09 - 2011
BTD141, BTD141Z, BTD141H2
18V IMPACT DRIVER KIT

SERVICE CHANGES

1. Changes on Hammer Case Cover and Bumper

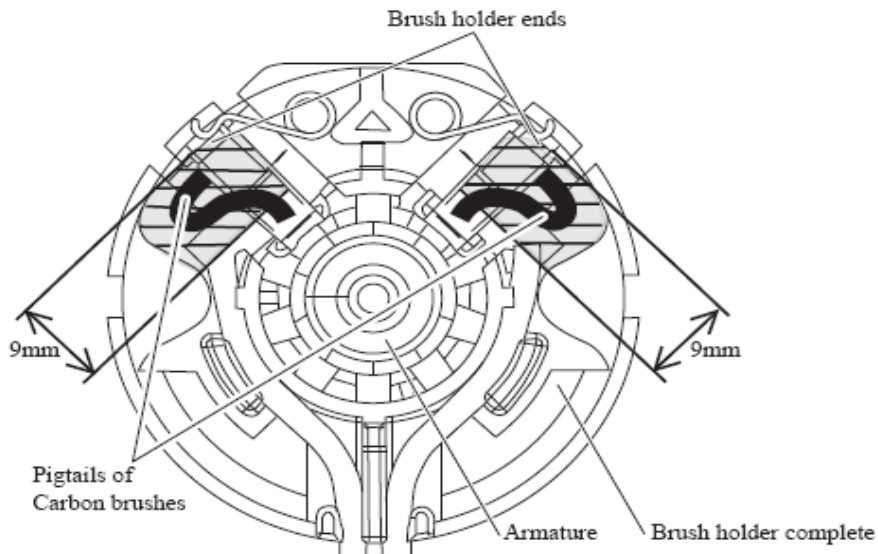
Item No.	Description	Type 1	Type 2
14	Bumper	424015-7	424369-2
15	Hammer Case Cover	450585-0	452409-6

Above parts are completely interchangeable as a set.

Type1: Bumper is hooked with the grooves of Hammer case.

Type2: Bumper is hooked with the protrusions of Hammer case cover as illustrated below.

2. Changes How to Assemble Carbon Brushes

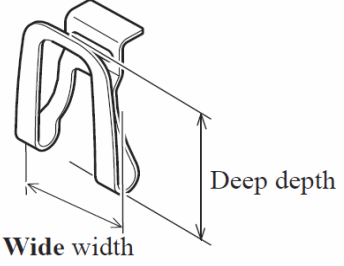
Item No.	Description	Type 1	Type 2
36	Carbon Brush	194427-5 (W/O ORIGIN)	195021-6 (W/ ORIGIN)

Do not protrude the pigtails of Carbon brushes from the specific spaces.

Refer to the following illustration.
